DESCRIPTIVE REPORT

Type of Survey HYDROGRAPHIC
Field No. N/A
Registry No. H11249

State Alaska
General Locality Cook Inlet
Sublocality North Point Shoal to Knik Arm

Descriptive Report to Accompany Hydrographic Survey H-11249

Figure D.1.2

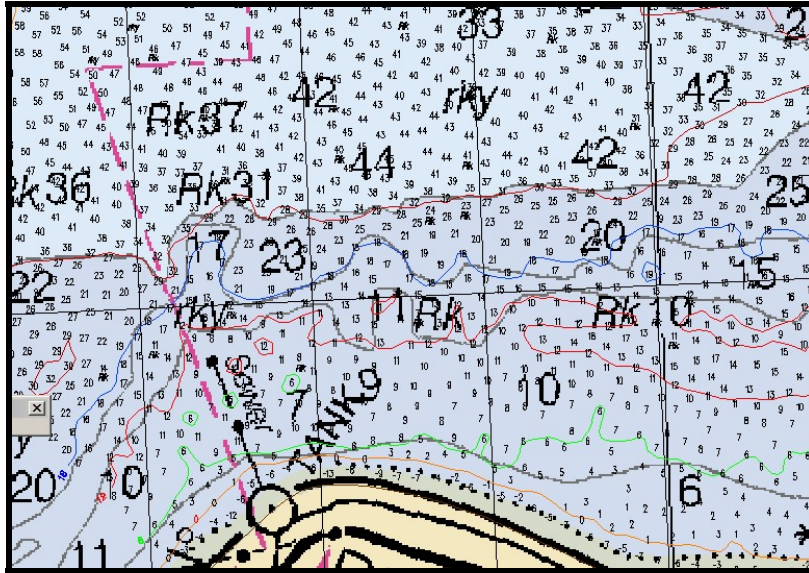
The rock field north of Point Woronzoff has some additional rocks and is represented by the “rky” and “Rk” symbols. The hydrographer recommends retaining the symbols as charted in this area.¹⁸

¹⁸ Do not concur. Chart the area as shown on the Hdrawing.

New Rock
Figure D.1.3

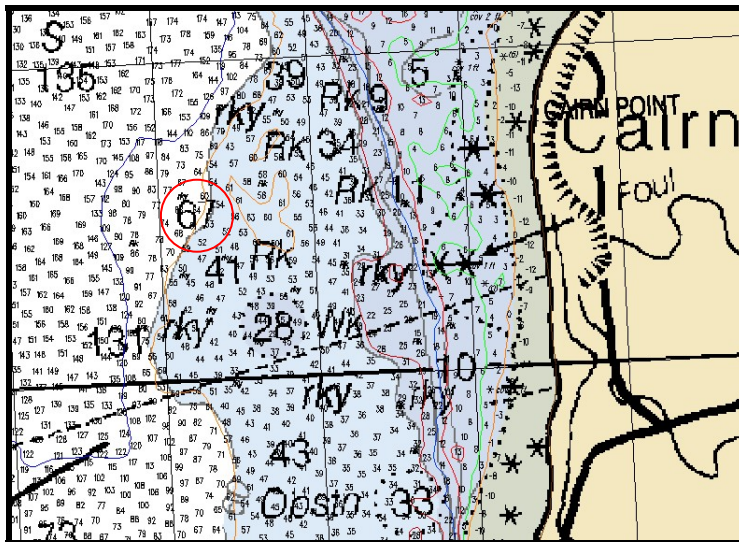
The rock field west of Cairn Point has additional rocks. The hydrographer recommends an additional “rky” symbol near the 2004 67-foot sounding at latitude 61°15’16.13”N and longitude 149°53’52.67”W.¹⁹

¹⁹ Do not concur. Chart the area as shown on the Hdrawing.

Additional Foul Area
Figure D.1.6

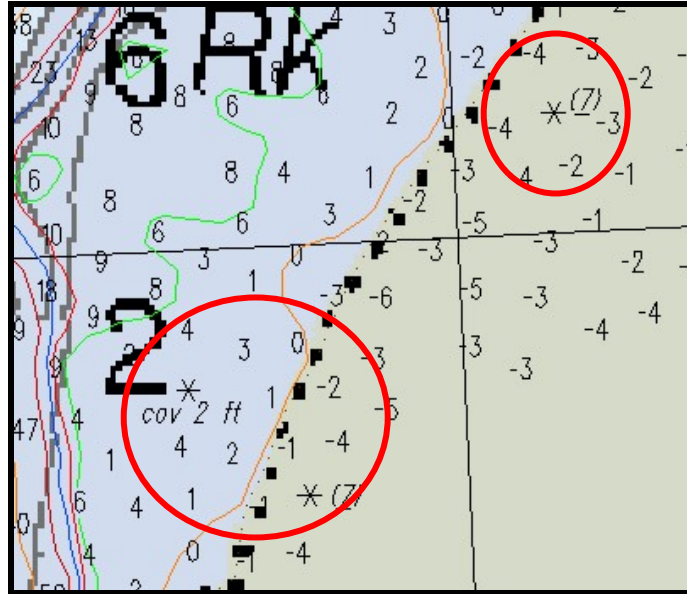
<u>Latitude N</u>	<u>Longitude W</u>	<u>Depth Feet</u>
61°15'29.12"	149°52'51.53"	-5.65
61°15'28.85"	149°53'00.27"	1.19
61°15'27.31"	149°53'02.47"	3.05
61°15'33.69"	149°52'56.62"	2.05

The hydrographer recommends adjusting the foul line to include the new rocks on the next chart edition. ²⁵

²⁵ Concur

New Rock
Figure D.1.7

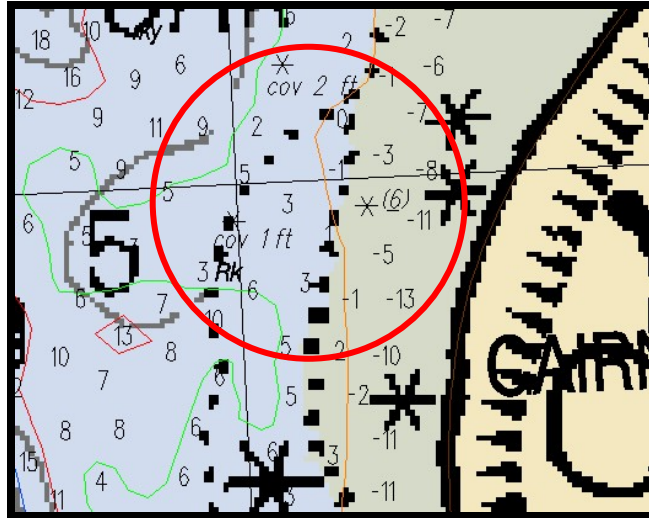
<u>Latitude N</u>	<u>Longitude W</u>	<u>Depth feet</u> <u>MLLW</u>	<u>Hydrographer's</u> <u>Recommendation</u> <u>Next Chart Edition</u>
61°14'14.24"	149°54'35.25"	69.24	Add Rk ²⁶

²⁶ Do not concur. Chart area as shown on the Hdrawing.

New Rock
Figure D.1.11

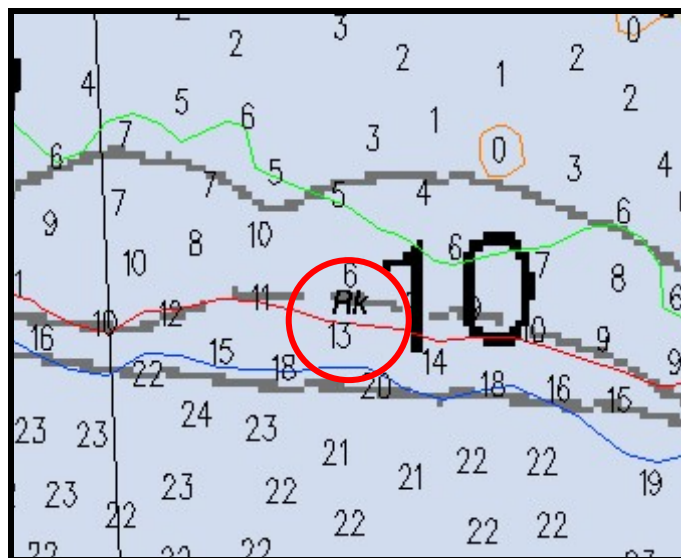
<u>Latitude N</u>	<u>Longitude W</u>	<u>Depth feet MLLW</u>	<u>Hydrographer's Recommendation Next Chart Edition</u>
61°15'18.376"	149°55'54.859"	2.22 above MLLW	Add <u>* (2)</u> ³⁰

³⁰ Concur with clarification. Chart as shown on the Hdrawing.

Figure D.1.13

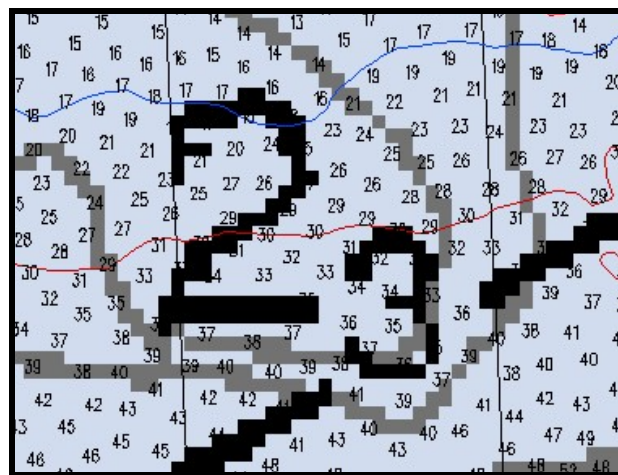
The 2₃ fathom (12.3 feet) sounding has 2004 soundings as deep as 32 feet in the same location. The hydrographer recommends updating the next chart edition with the 2004 soundings.⁴¹

-
- 31 Concur
- 32 Concur
- 33 Concur
- 34 Concur
- 35 Concur
- 36 Concur
- 37 Concur
- 38 Concur
- 39 Concur
- 40 Concur
- 41 Concur with clarification. There is a 12' (2 fathoms) (61/14/26.2N, 149/56/22.5W) near the 2 fathom 3 feet sounding. The 2 fathom 3 feet sounding was not shown on the latest continuous maintenance drawing for chart 16660 reviewed by PHB. Chart as shown on the Hdrawing.

Figure D.1.18
New Rock

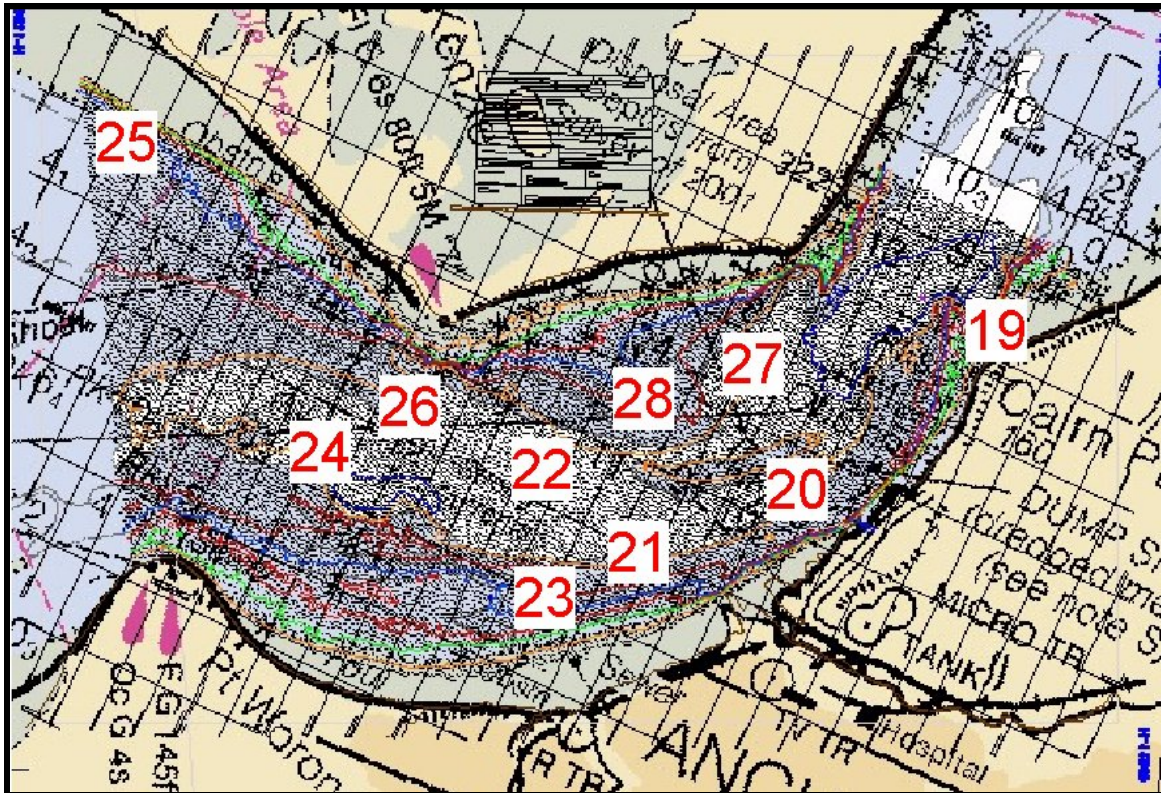
<u>Latitude N</u>	<u>Longitude W</u>	<u>Depth feet</u> <u>MLLW</u>	<u>Hydrographer's</u> <u>Recommnedation</u> <u>Next Chart Edition</u>
61°12'32.28"	149°59'01.51"	10.70	Add <i>Rk</i> ⁴⁶

- 42 Concur
- 43 Concur
- 44 Concur
- 45 Concur
- 46 Concur with clarification. Chart as shown on Hdrawing. Smooth sheet shows a 10.7 ft sounding in the position of the 1 fathom 1 foot shown in the chartlet below.

DTM showing discovered wreck with Chart 16665 8th ed. and 2004 soundings

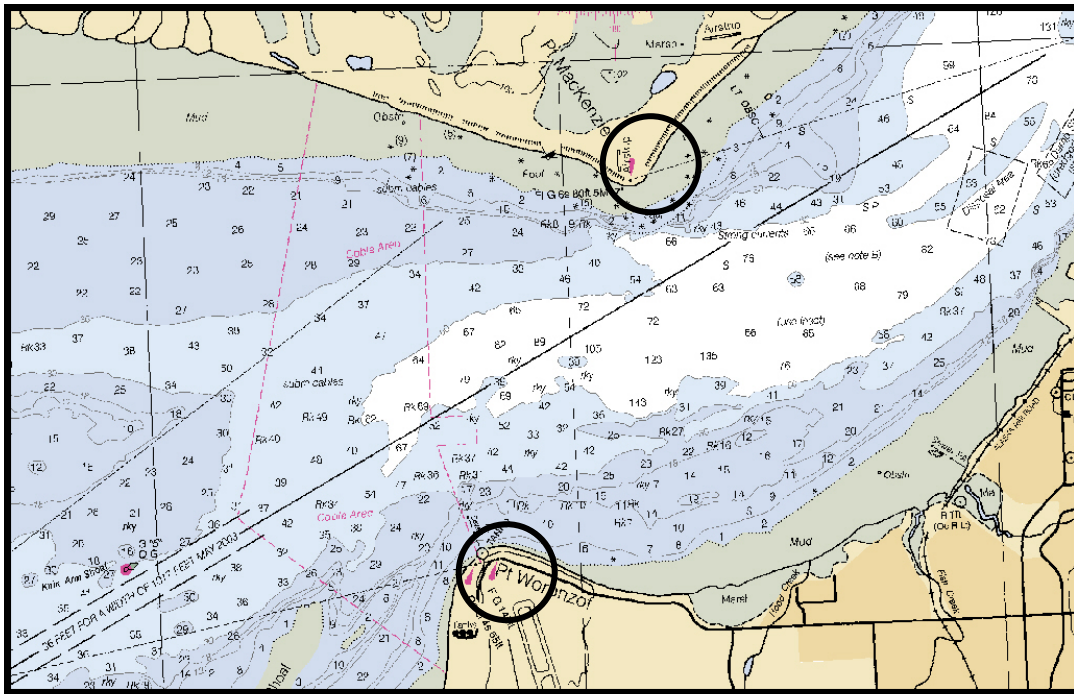
The Local Notice to Mariner ID #13 was submitted by Terra Surveys, LLC, and the USACE outside the scope of this contract, while surveying for the Port of Anchorage. A sunken barge or “pill box” was discovered and moved by dredgers. The area was first surveyed as contracted for NOAA on DN 165. The area was surveyed again on 262 to fill in data gaps allowing the hydrographers to detect the barge. It should be noted that the NOAA survey puts the barge’s position approximately 100 meters southwest from the Local Notice to Mariners position, which was submitted to the nearest decimal minute. Refer to Appendice I of this report for correspondence related to this wreck.

The differences in the least depth values between the two surveys are most likely a result of the barge’s position at the time of each survey.⁷¹

The hydrographer recommends the least depth be verified through diver investigation. This DTON was reviewed by Capt D.T. Glenn of the USCG, who determined it did not qualify as a “hazard to navigation”. Refer to Appendice I for correspondence regarding this finding.⁷²

⁷² Concur with clarification. Chart 29 foot wreck at surveyed location. The area was not resurveyed after the barge was moved. It has not been disproved at this location. The 19 foot wreck at 61/15/03.6N, 149/53/10.9W is not shown on the Hdrawing a 15 foot Rk supersedes in this location. PHB recommends the wreck be added to the AWOIS database.

Asbuilt of deep draft dock addition to Port MacKenzie

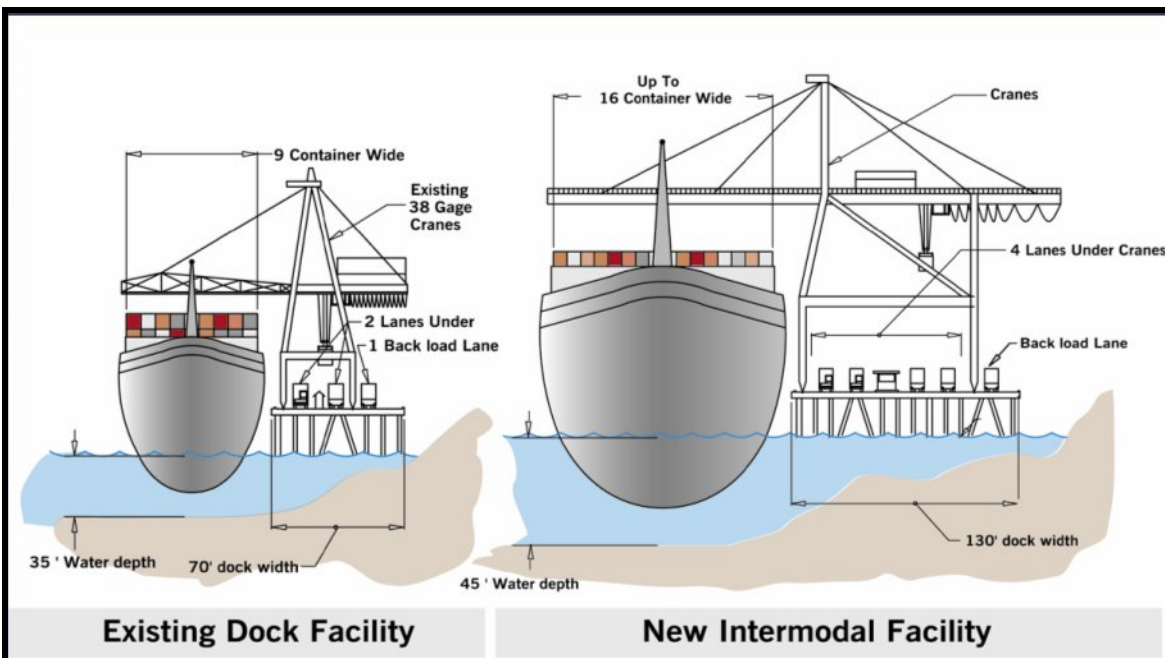
In addition to an existing 500-foot bulkhead, construction for a 1200-foot deep draft dock began in August 2004.⁷⁶

⁷⁶ Concur with clarification. Chart pier facility with the latest "as-built" information. PHB recommends revising the inset for Chart 16665 to include the Port MacKenzie pier facility.
